## 2025/1615/P & 2025/1664/L - 61 Gloucester Crescent

<b>Delegated Report (Members Briefing)</b>		<b>Analysis sheet</b>		<b>Expiry Date:</b>	<b>09/06/2025</b>
		n/a		<b>Consultation Expiry Date:</b>	<b>18/05/2025</b>
<b>Officer</b>			<b>Application Number</b>		
Tony Young			1. 2025/1615/P 2. 2025/1664/L		
<b>Application Address</b>			<b>Drawing Numbers</b>		
61 Gloucester Crescent London NW1 7EG			Refer to draft decision notice		
<b>PO 3/4</b>	<b>Area Team Signature</b>	<b>C&amp;UD</b>	<b>Authorised Officer Signature</b>		
<b>Proposal</b>

1. <u>Householder application</u> & 2. <u>Listed building consent application</u> External alterations to existing front boundary brick wall and pier to provide enlarged vehicular access space, installation of black cast iron automated sliding vehicular gate and pedestrian gate, replacement composite wood bin store in front garden, and replacement of concrete paving to existing driveway with sandstone paving.					
<b>Recommendation</b>	1. Grant Planning Permission 2. Grant Listed Building Consent				
<b>Application Type</b>	1. Householder 2. Listed Building Consent

Image 4 – showing relative proximity of existing brick pier and car at application site

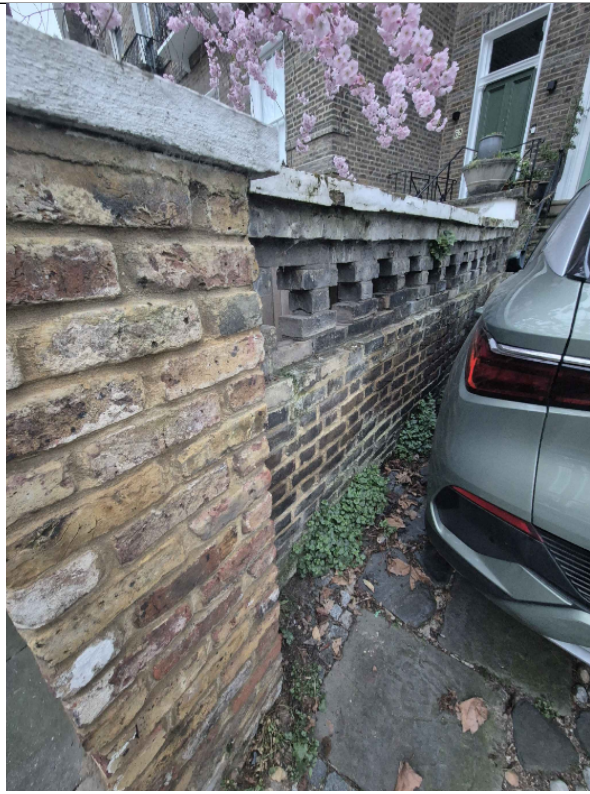
3.9 An existing vehicle crossover connects the driveway and off-street parking space at the application site to the road. Any car entering or exiting the driveway therefore must pass between two brick piers on the left-hand side of the front boundary; the width between both piers being just 2.29 metres.

3.10 As such, manoeuvring a vehicle into or out of the driveway, across the pedestrian pavement, to and from the vehicle crossover, is difficult and significantly restricted given the narrowness of the opening. This presents safety concerns for both driver and pedestrians on a daily basis, has resulted in frequent damage to the exterior of the applicant's car when attempting to pass between both piers, causes daily hindrance and inconvenience to the applicant, and significantly limits the safe functional use of the driveway (see Image 4 below).

Image 6 – proposed front boundary at the application site

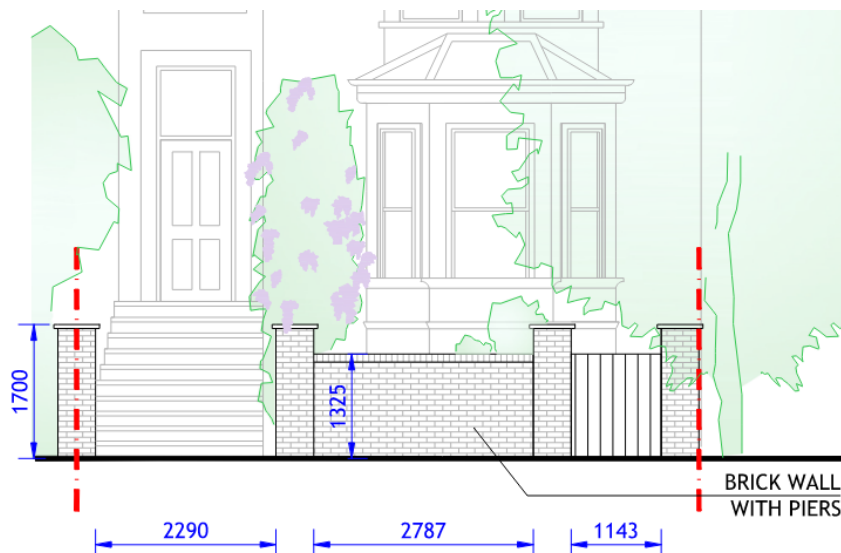
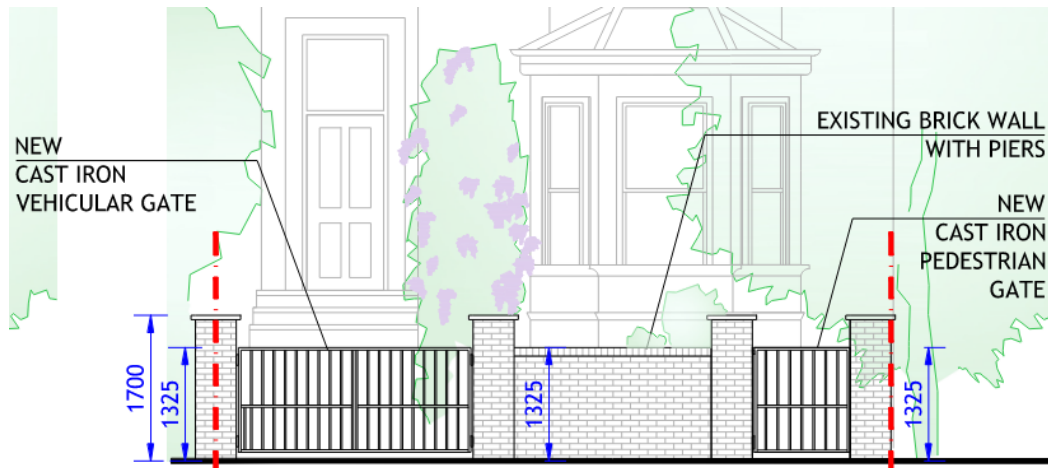
- 3.11 To improve this situation, the applicant proposes that the space between the two brick piers is widened by 48 centimetres (to 2.77 metres). In order to achieve this, an existing brick pier and very small part of the brick wall would be carefully dismantled and rebuilt slightly further to the right-hand side, using salvaged London stock bricks and coping stones to closely match existing materials and appearance. As stated above, the existing wall and piers appear to be relatively new additions, built sometime after 2009, which included the addition of the brick pier now proposed to be dismantled and rebuilt.

- 3.12 Additionally, an automated sliding vehicular gate and a pedestrian gate would be installed, both made from cast iron and black in colour. Following concern raised by the Council to the excessive height (approximately 1.6 metres high) and inappropriate design of both gates, the applicant has provided revised drawings showing both gates to be reduced in height (to approximately 1.3 metres high) so as to more appropriately match the existing height of the central boundary wall. Decorative spikes as originally proposed, have also been removed and replaced with a simpler, matching design for both gates, and which now appear more subordinate to the character of the host building (see Images 5 and 6 below).

Image 15 – existing concrete hardstanding in front garden of application site

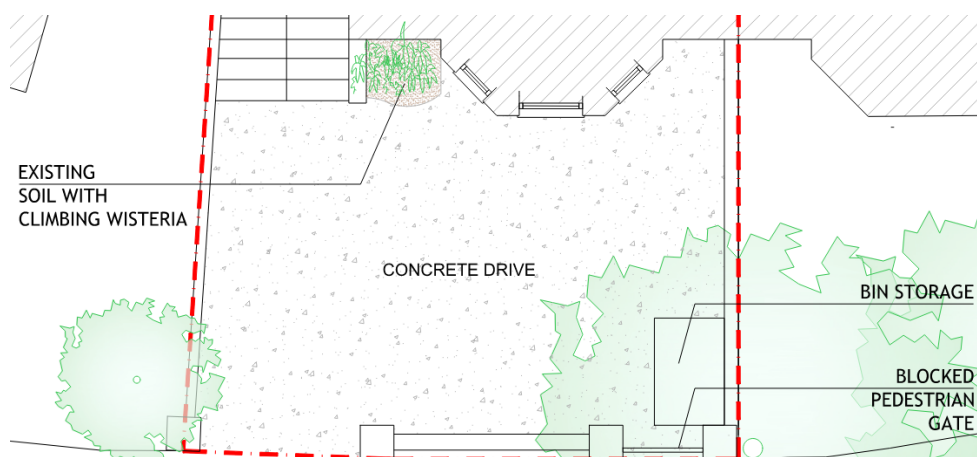
- 3.19 The majority of the area of the front garden is covered by a concrete hard surface which is in very poor condition (see Image 15 below).

Image 16 – proposed sandstone paving in front garden of application site

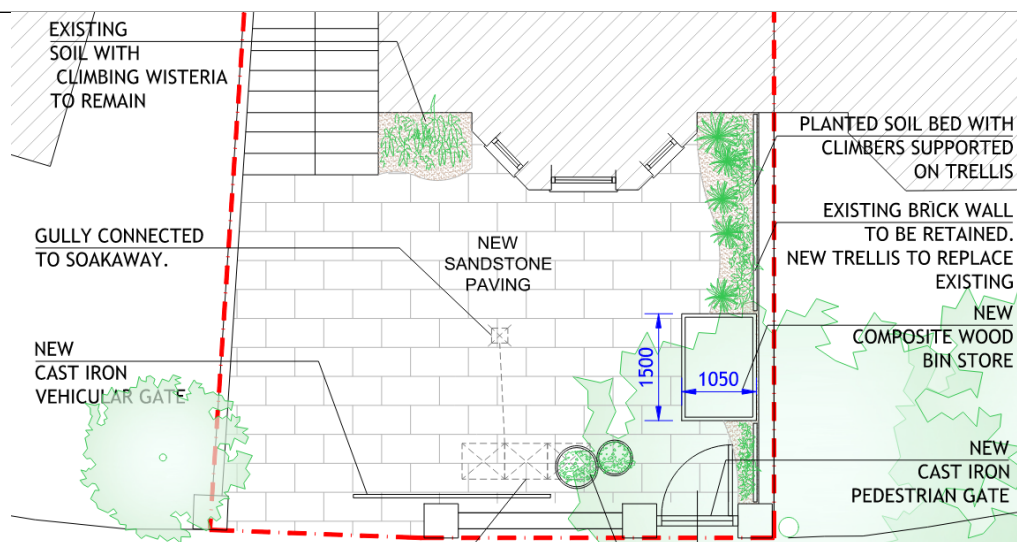
- 3.20 The proposed replacement of the existing concrete hardstanding with sandstone paving, along with a small amount of additional green planting, is considered to be a sympathetic alteration that would preserve the existing character and appearance at the front of the property and streetscene generally (see Image 16 below).

3.21 The proposed sandstone material and paving arrangement would allow rainwater to permeate into the ground more readily and reducing surface runoff, supported by proposed soakaway crates which help capture and disperse water into the ground. This would provide a sustainable drainage solution (SUDS) helping to mitigate the risk of any potential flooding and ensuring that an acceptable level of rainwater attenuation and drainage management would be present at the property following the proposed works.
